# City of Sonora
## 94 N. Washington Street
## Sonora, CA 95370
## Parking & Traffic Commission Request

SONORA HIGH SCHOOL
COSMETOLOGY BUILDING
606 SHAWS FLAT RD
Sonora, CA

**From:** Gerard J. Fuccillo <gjfeng@sbcglobal.net>
**Sent:** Friday, August 03, 2018 10:40 AM
**To:** Kim Campbell; Sheala Wilkinson
**Cc:** Mike Lagomarsino
**Subject:** Parking in front of the Sonora High Cosmetology Building on Shaws Flat Road
**Attachments:** Cosmetology Bldg Sidewalk plan -Shaws Flat-2011-opt.pdf

Spacial Adjacency Diagram

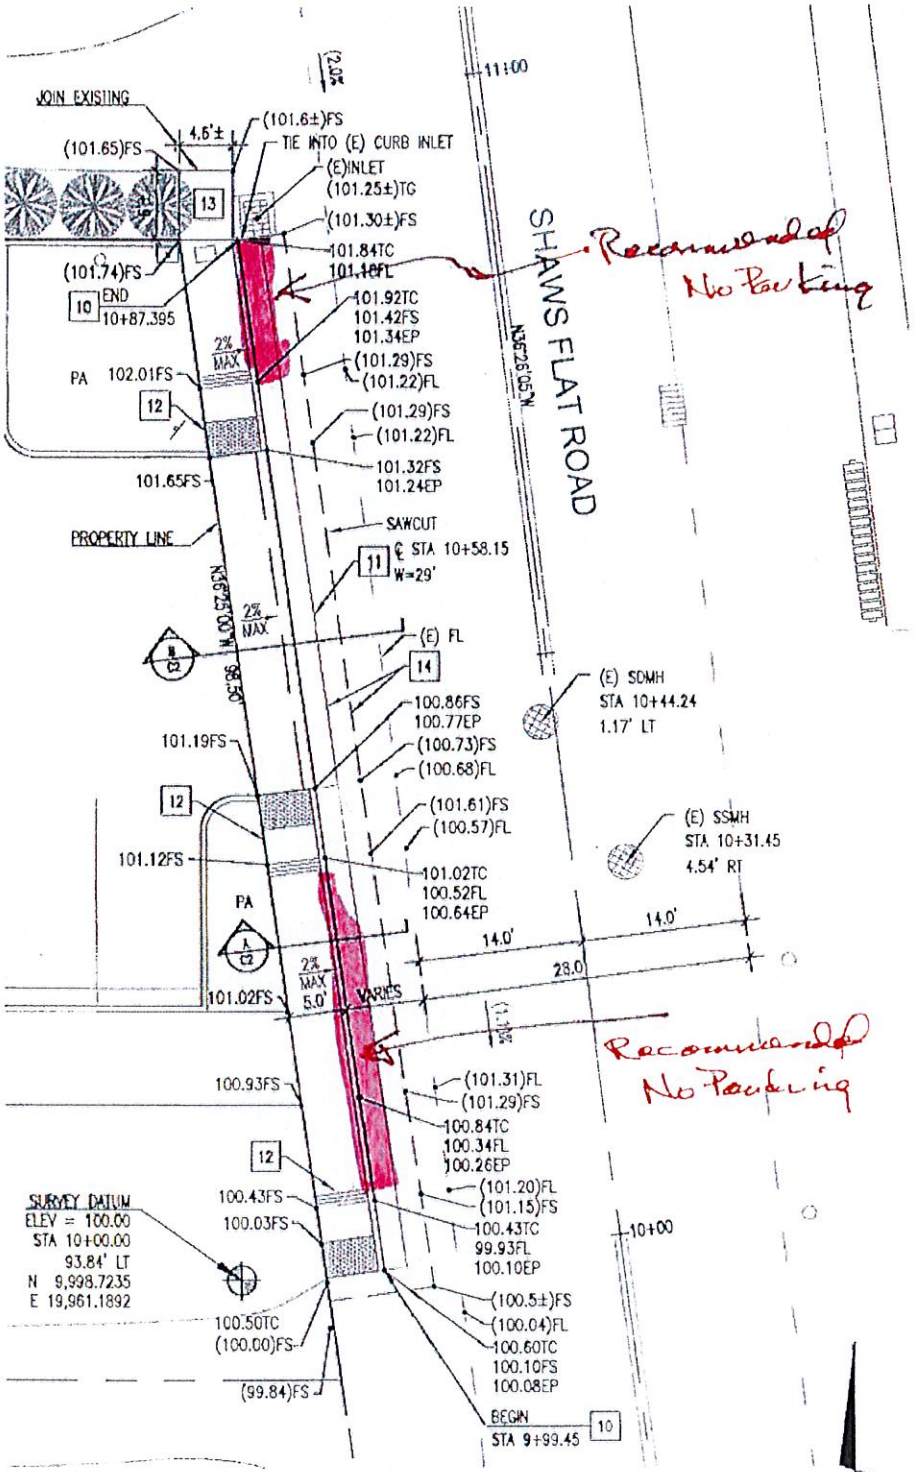
*Attached is a copy of the SHS plan of the Cosmetology Bldg sidewalk on Shaws Flat Road marked up with recommended no parking zones.*

*I have reviewed the matter of parking along the frontage with Mike Lagomarsino, and agree that there should be a no parking zone on both sides of the driveway to the building parking lot.*

*The reason for this recommendation is that the parking lane is too narrow along the sidewalk, and there may be conflicts with in and out traffic to the parking lot as well as the private driveway to the south.*

Make no parking in front of address
